6.1 15-37 BANK STREET, SOUTH MELBOURNE -  
PDPL/00890/2022

1.1 To consider and determine planning permit application PDPL/00890/2022 to construct a multi-storey mixed use building on land in the Mixed Use Zone and Design and Development Overlay and Special Building Overlay and associated reduction of car parking at 15 - 37 Bank Street, South Melbourne.

6.2 The plans subject to this application are those prepared by RotheLowman entitled “*Bank Street*”, Revision B dated 8 May 2023 (with exception of TP01.22 which is identified as Revision A dated 8 May 2023), Council date stamped 15 May 2023 and advertised.

*Figure 12 - Ground-floor plan showing the cross-block link southern end. The pedestrian footpath is highlighted in orange with the pinch point in question outlined in red*

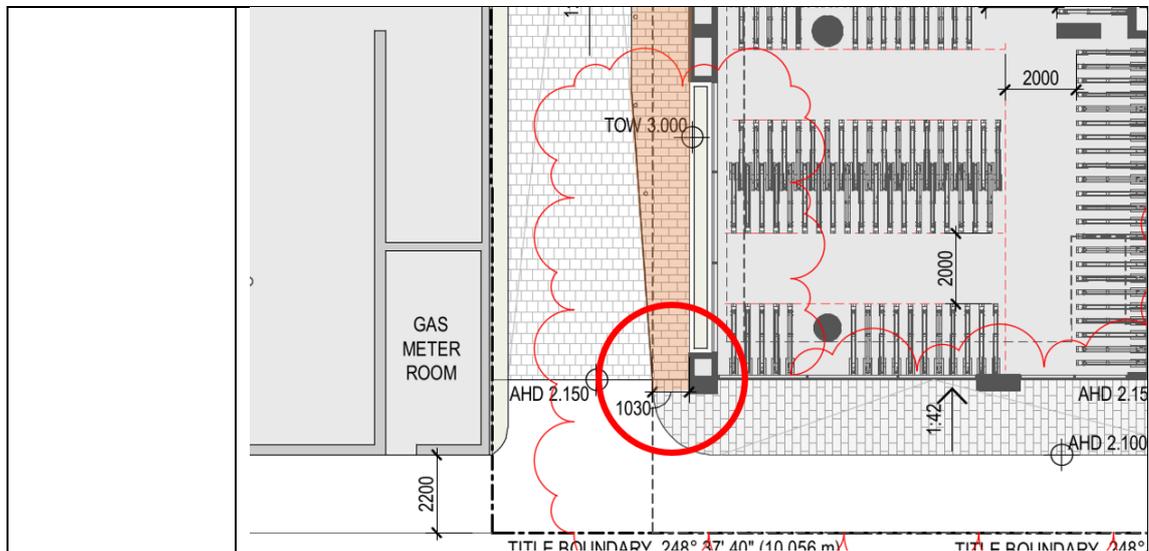
It is noted that Council's Urban Design Advisor generally supports the proposal subject to resolution of the 'pinch point' between the vehicle access way and pedestrian path at the south of the cross-block link.

Figure 12 above shows the footpath to the cross-block link reducing to a width of 1m at its southernmost edge.

Whilst it is suggested that the pedestrian colonnade has been addressed, it is noted that the design of the colonnade did not change between the pre and post-RFI plans. As such it is still considered an issue from an urban design perspective.

Figure 14 - Proposed site plan showing the proposed 57.3m wide tower at the rear to Little Bank street.

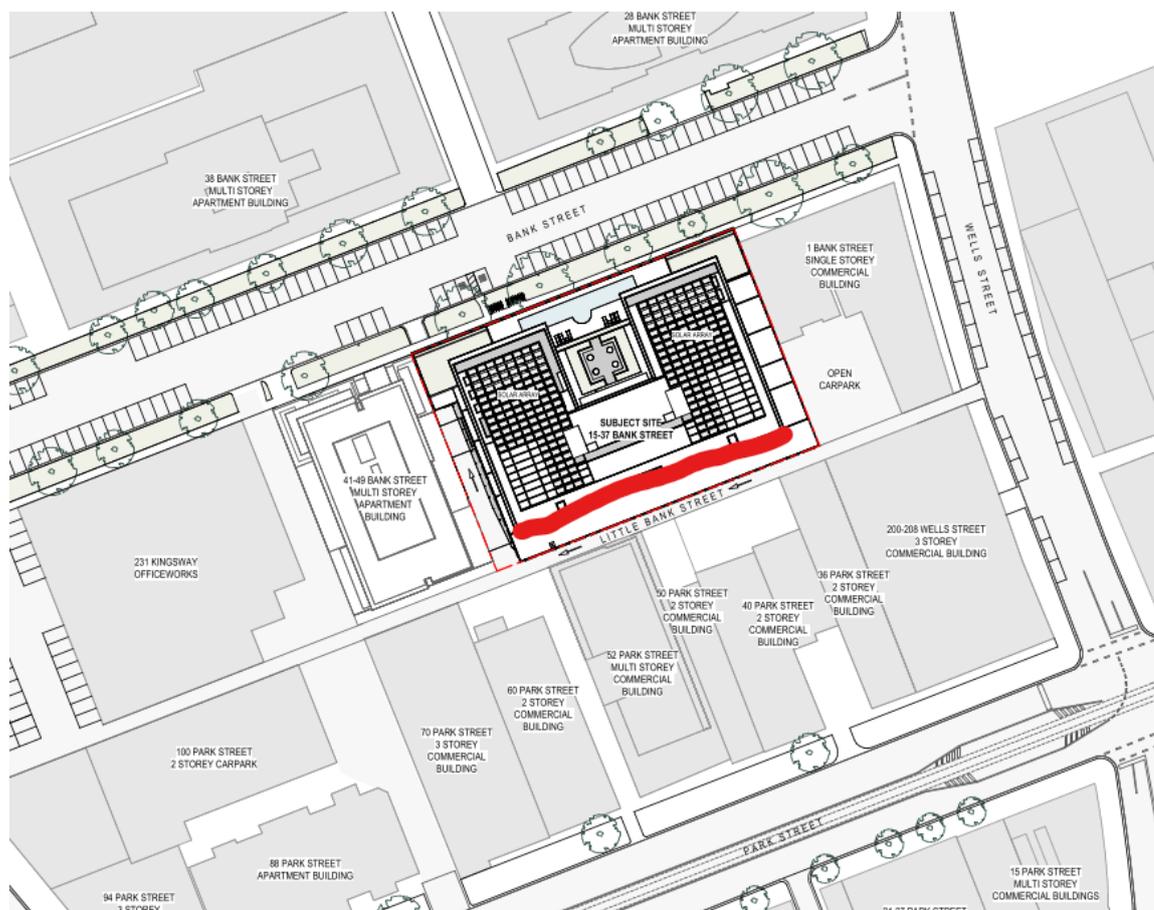
The width of the tower at 57.3m would present as a monolithic structure with the Bank Street and Little Bank Street context. Further, the wall would be an imposing structure as read from the north-facing apartments of existing and future development of those lots south of Little Bank Street and from Park Street itself.

There is no sound justification for the width of the tower to be this significant. The site is large and combines three-lots. It has sufficient flexibility to mass built-form in such a way that would not require such a drastic built form width. The proposal as it stands is considered to have an unacceptable amenity impact on the dwellings to its south and to future development south of Little Bank Street.

On review of the plans, it is recommended that the apartments to be removed would constitute the central two apartments between levels 6 and 18. Below level 6 the tower would largely be integrated with the podium level and no change would be considered necessary.

Figure 18 - Elevation showing the 60m height limit and offending structures (and their height) above the height limit

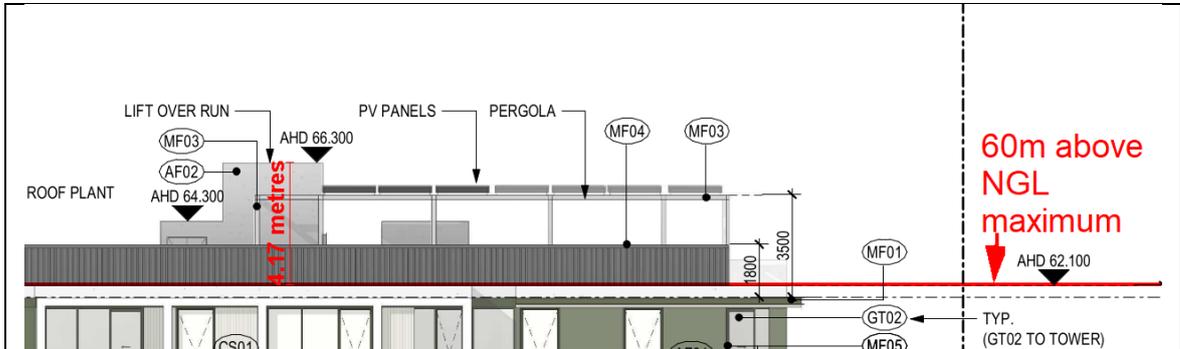
<p><i>Development beyond the setbacks identified above must not exceed a height of 60 metres. A permit may not be granted to construct a building or construct or carry out works which are not in accordance with this requirement unless allowed by Clause 2.3 of this schedule.</i></p>	<p>Refer below.</p>
<p>The height of the building would rise to 60m above natural ground level. There would be additional structures located above this height that the applicant suggests are permitted by Clause 2.3 of the Schedule.</p> <p>Structures located above the 60m height consists of plant screening, lift overruns, roof balustrades, and two large pergola structures.</p> <p>The two large pergolas would extend approximately 3m above the 60m height limit. These structures would be fitted with solar panels on their roof structure which would slightly raise the height by an unspecified extent. .</p> <p>Figures 18 and 19 below demonstrate the extent of these structures sitting above the 60m height limit.</p>

<p>With respect to the pergola structures, the proposal does not comply with this requirement. The pergola structures do not constitute architectural features, or building services irrespective of solar panels on their roof. The intent of this provision is to allow more minor structures such as balustrades, landscaping fixtures, and explicit building services not a significantly sized roofing structure.</p> <p>Should a permit be recommended, it will include a condition to remove the offending pergola structures from the rooftop terrace. <b>(Refer recommended condition 1f).</b></p> <p>To make it explicitly clear to the applicant, an additional condition stating that building services on the rooftop (excluding solar panels) must not exceed 10% of the gross floor area of the top building level or 50 square metres (whichever is greater) will be applied. <b>(Refer recommended condition 1h).</b></p> <p>The balance structures proposed above the 60m height limit are considered to be acceptable with respect to Clause 2.3. This includes the balustrades, screening and fencing to plant areas, lift and stair core enclosures, and a small raised deck area to the western terrace.</p> <ul style="list-style-type: none"> <li>- <i>Within Sub-Precinct 2 and Sub-Precinct 3, allow the construction of a green roof (defined as a vegetated landscape built up from a series of layers that are installed on the roof surface as 'loose laid' sheets or modular blocks) or communal open space that does not exceed the mandated building height by more than 2 metres.</i></li> </ul> <p>Green areas are proposed on the rooftop terraces. The submitted landscaping plans suggest that planter boxes would be proposed on the rooftop however these would be limited to 1.2m above the FFL of the rooftop terrace. This is considered acceptable with respect to the above requirements.</p>

*Figure 20 - Proposed ground-floor plan showing the extent of visitor bicycle parking located on Bank Street.*

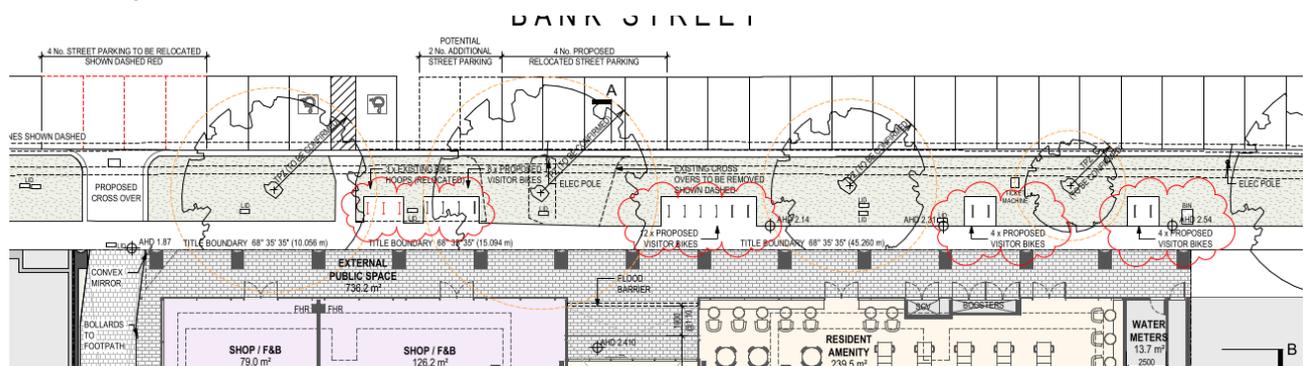
As discussed earlier in this report, the location of visitor spaces however is problematic. The applicant seeks to utilise a large proportion of the green nature strip area for visitor parking spaces. See *Figure* below.

There is no clear justification provided for why this approach should be supported. The requirement for providing the visitor bicycle parking spaces is directly attributable to the proposed privately owned development that is located on a substantially large three-lot development. As is expected with all developments, visitor bicycle parking should be provided on the subject land noting its triggered by private development interest.

As such, should any permit be recommended, it will include conditions to remove all visitor bicycle parking spaces from the street and be located on the land. (**Refer recommended condition 1i**).

Figure 21 – Proposed (and supported) flood barrier strategy

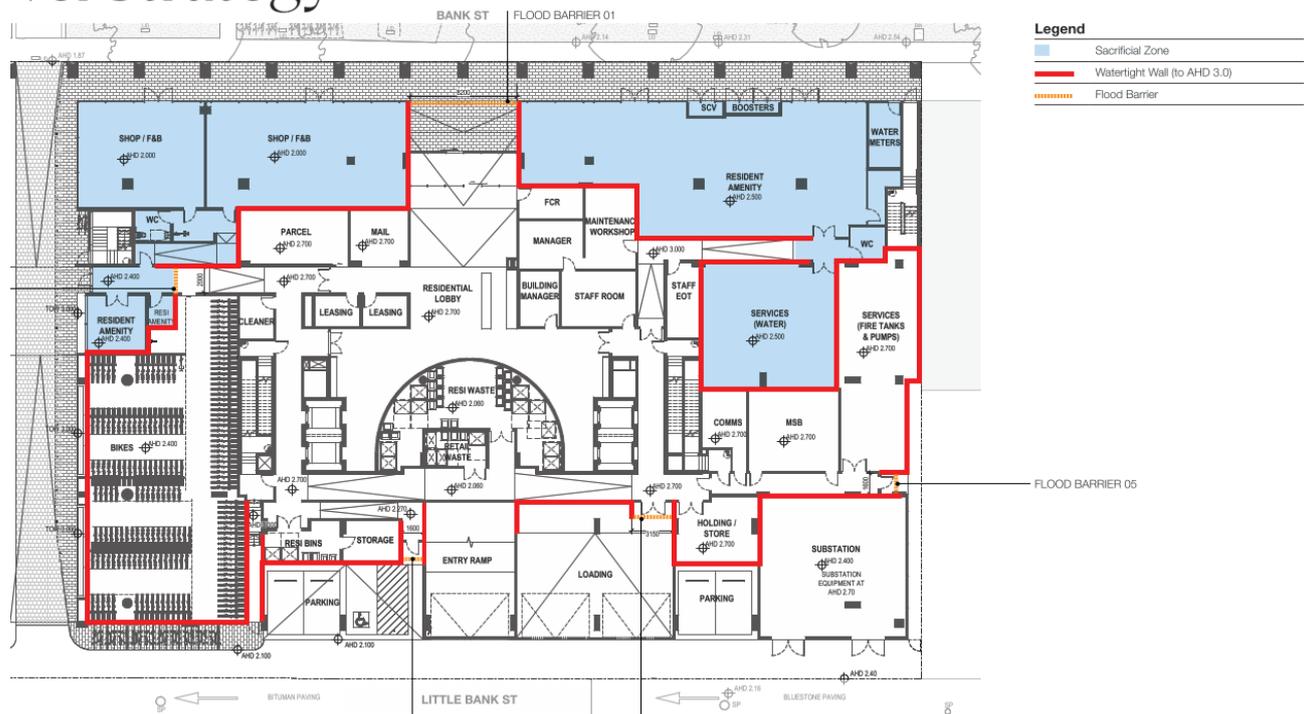
It would however require a revised flood barrier strategy to the relocated residential lobby. The current scheme provides no flood proofing of the two sacrificial retail premises and sacrificial residential amenity area.

There may be a requirement for some form of setback between the residential lobby and Bank Street to enable sufficient room for the flood barrier. Noting this, some flexibility will be included in the recommended condition to ensure this can be maintained in the post-permit approved scheme.
